ISSUE: Permit to Demolish/Capsulate (partial) and Certificate of Appropriateness for alterations

LOCATION: Old and Historic Alexandria District
518 South Fairfax Street

STAFF RECOMMENDATION

BAR#2025-00008 & BAR#2025-00009 OHAD
518 S Fairfax Street

S. FAIRFAX ST. STREET
PROPOSED NORTH SIDE EXTERIOR ELEVATION

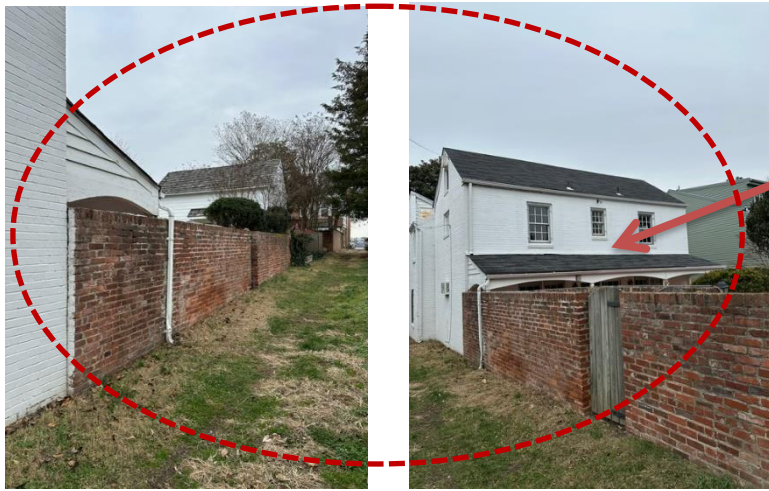
In the current configuration, the north elevation is a collection of additions and building features that lacks a sense of continuity and overall composition (Figure 7). These additions have changed the design of the building to such an extent that the original building design has been lost. The applicant is proposing modifications to this portion of the building that will serve to organize the massing and simplify the composition. The vertical extension of the single-story portion and the horizontal addition immediately adjacent to this area will create a single plane that is aligned with the existing front section. At the recessed second floor area, the applicant will be replacing the existing aluminum siding and replacing it with fiber cement siding that complies with the relevant BAR requirements. The submission does not specify the finish for the fiber cement, so staff recommends the condition that a smooth finish be used in lieu of a wood grain finish.

Staff finds that the proposed modifications to the north elevation are appropriate for the building and will help to organize this portion of the building. The resulting composition will be respectful of the history of the building and will not compete with the more prominent western façade. As such, staff supports the proposed modifications to this section of the building.

Several new windows are proposed to be installed on the north and south elevations. Please verify that the proposed design complies with VRC Section R302.1 for fire-resistant construction.

1. The entry door on the west (Fairfax Street) elevation remain in the existing location.
2. Fiber cement siding be installed with a smooth finish

PROPOSED SOUTH SIDE EXTERIOR ELEVATION
(EXISTING BRICK WALL NOT SHOWN FOR CLARITY)

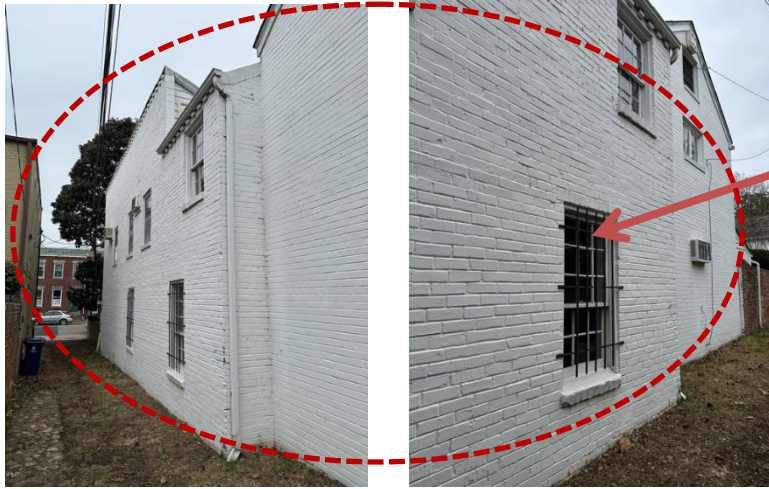
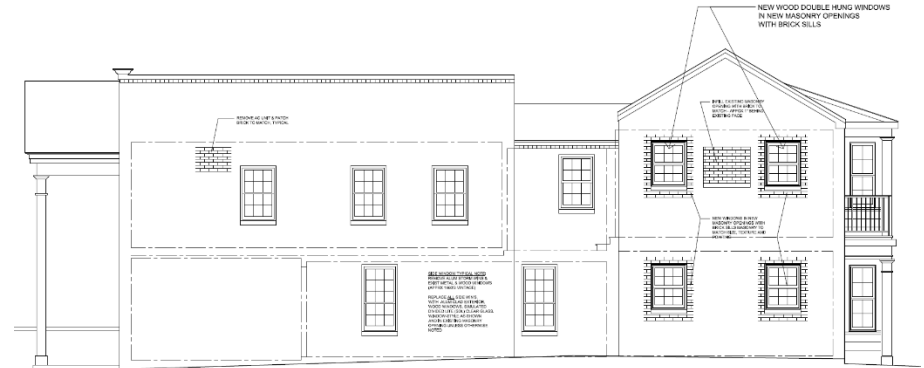
The changes to the south elevation include the removal of one window and the installation of four windows on the rear addition and the removal of through-wall air conditioner units and ground floor window security bars (Figure 8). While this portion of the building is visible from a public right of way when looking down the adjacent alley, it is only at an oblique angle. The change from one window to four windows will match the configuration on the north elevation and occurs on the least visible section of this elevation. The modifications on the front section of this wall are improvements to the existing condition and will improve the overall appearance.
